**Medius House**  
NMA

February 2023 - Revision A

This document is prepared in support of an NMA for Medius House detailing the proposed omission of the glazing bars to the fire rated glazing at the rear of the property.

Elevation submitted as part of the this NMA pack - with windows highlighted where glazing bars are to be omitted

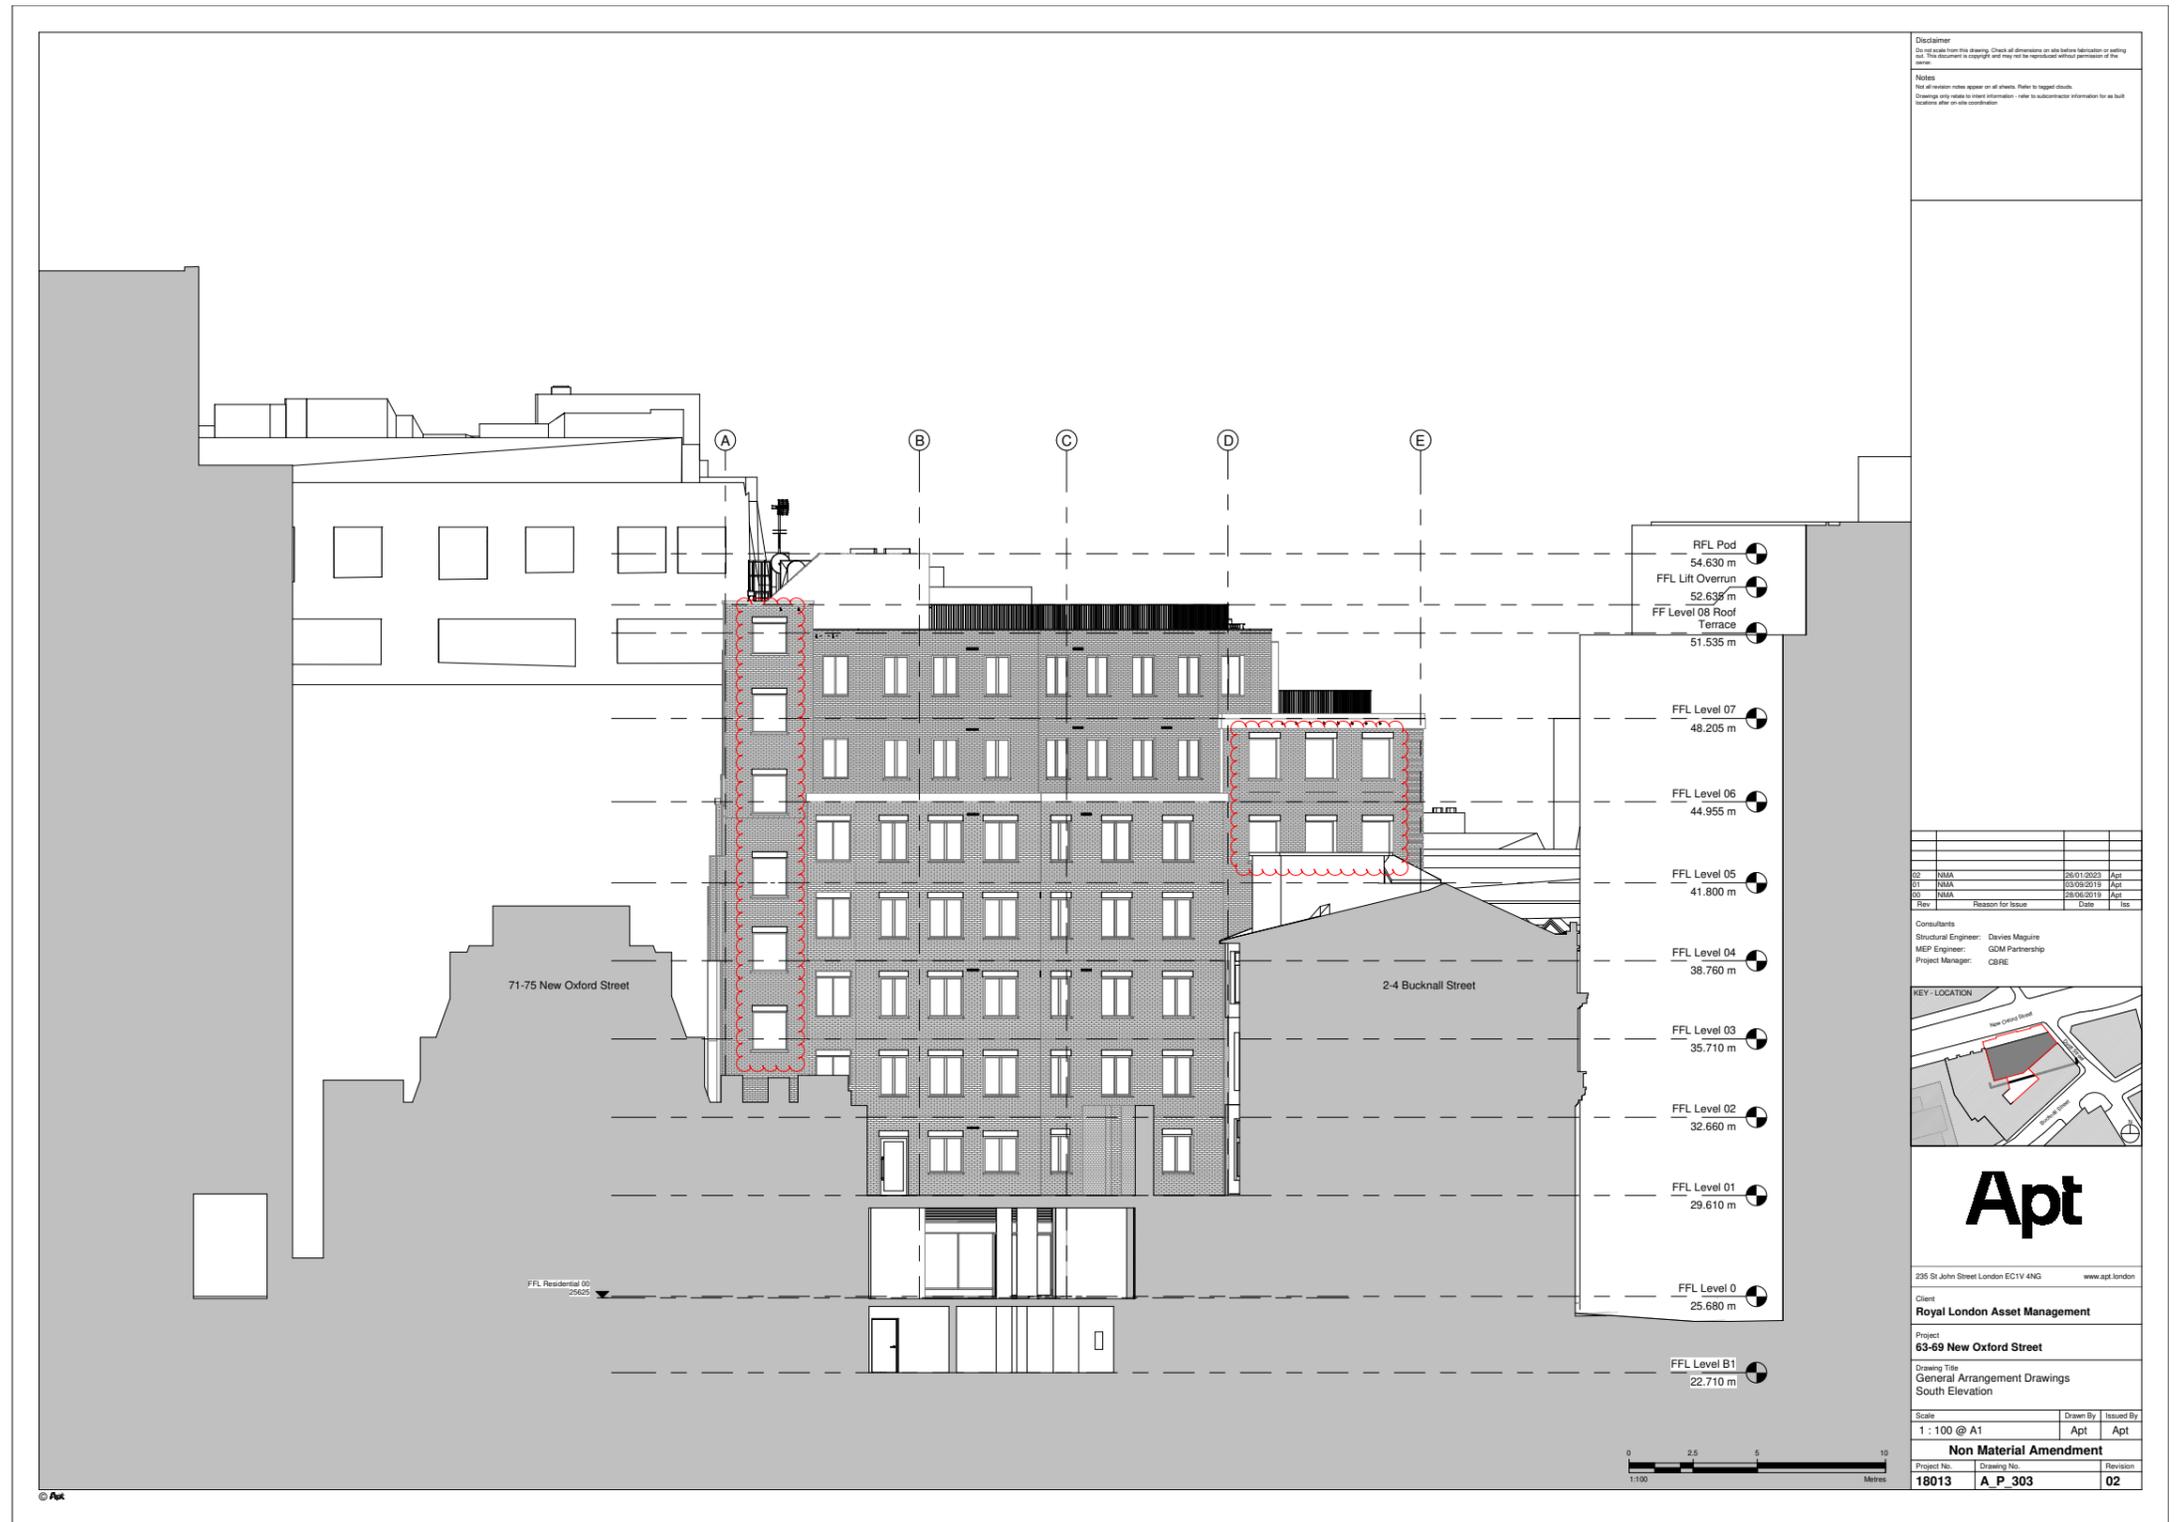
The fire rated windows were detailed within the approved elevations as having Georgian style glazing bars, however due to the technical requirements of the fire rated glazing in these locations (please refer to highlighted elevations below) the bars are unable to be fixed mechanically. This has resulted in the failure of the bars adhesive bond to the glass and they are now presenting a safety concern. The project specialist contractor has exhausted all technical solutions to comply with the approved elevations and it has been confirmed that it is not possible to install / maintain a fire rated glazing system with integrated glazing bars to match the rest of Medius House, and they have therefore proposed the removal of the failed glazing bars.
